ORDINANCE 94-24

TO AMEND THE BLOOMINGTON ZONING MAPS FROM RS to BL,  
GRANT PCD DESIGNATION, AND APPROVE OUTLINE PLAN  
Re: 821 Anna Lee Lane  
(Ben Mitchell, Petitioner)

BLOOMINGTON PLAN COMMISSION  
FINAL REPORT  
Location: 821 Anna Lee Lane

CASE NO.: BL/PCD-26-94  
DATE: June 6, 1994

BL/PCD-26-94  
Site Plan

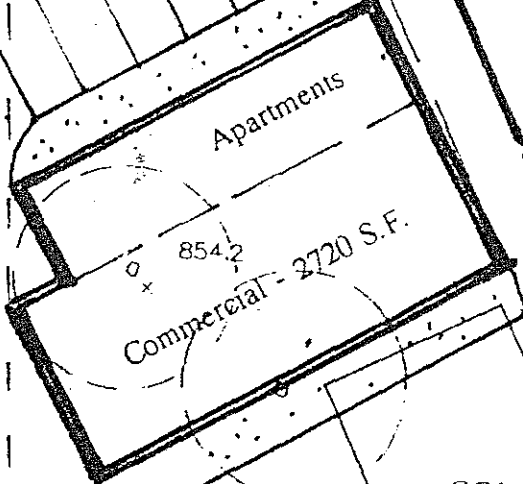
The petitioner will require variance from the 30' buffer and variance from access being provided from an arterial street. Both of these are PCD development standards. The petitioner has provided a 10' setback to the east and a 20' to the rear or north.

R.O.W. DEDICATION: A 50' right-of-way dedication from the centerline of Bloomfield is required. Anna Lee Lane will require 30' dedication.

TREE PRESERVATION: This plan will remove two silver maples from the interior of the lot. The Environmental Commission has reviewed this removal and agreed that the trees are undesirable for this kind of development. Staff continues to review the impact of expected entrance improvements on the six trees lining Bloomfield.

ACCESS: The Engineering Department has reviewed the plan and anticipates that all improvements to Bloomfield will be compatible in design to entrance improvements required by the PCD located directly opposite this site. A suggestion are accel and decel tapers on Bloomfield with additional 25' tapers to the double entrance off Anna Lee Lane. The petitioner will submit a traffic study at the hearing.

DRAINAGE: Calculations will be reviewed during Development Plan. Petitioner is alerted that some modification of the plan may be necessary if detention is required.

SIDEWALKS: Sidewalks are required on both frontages.

UTILITIES: Water is available, however the sewer construction anticipated in the area is not complete at this time. Previous approvals have required sewer service to this area. It has been delayed. Any approval of this site is contingent upon its completion. It is anticipated that provision will be complete by Development Plan approval, and no application will be accepted until completion of the line.

The site is largely flat and open, which should limit any problems with erosion control and drainage. Landscaping for the reduced setbacks is a development plan issue. At this stage, the only real issue is tree preservation. Eight silver maple trees are located on the property and all are of specimen quality. Most of the maples are along 2nd. St. The petitioner has indicated that all of these maples can be preserved with the help of a notch in the parking area that provides additional room for the northernmost tree. The two interior trees are the largest on the site but our measurements have them both located within the proposed building's footprint. Given the likely root span and brittleness that typically characterize older silver maples, the building's footprint would have to be shifted more than just a few feet to save these two interior trees.

-----  
RECOMMENDATION: Staff recommends approval with the following conditions:

1. Sewer provisions be completed before occupancy permits will be issued for this site.
2. Improvements along Bloomfield be consistent with improvements required on the south side of the street, design of site entrances to be resolved at Development Plan stage.
3. Analysis of the need for detention be required at Development Plan stage.
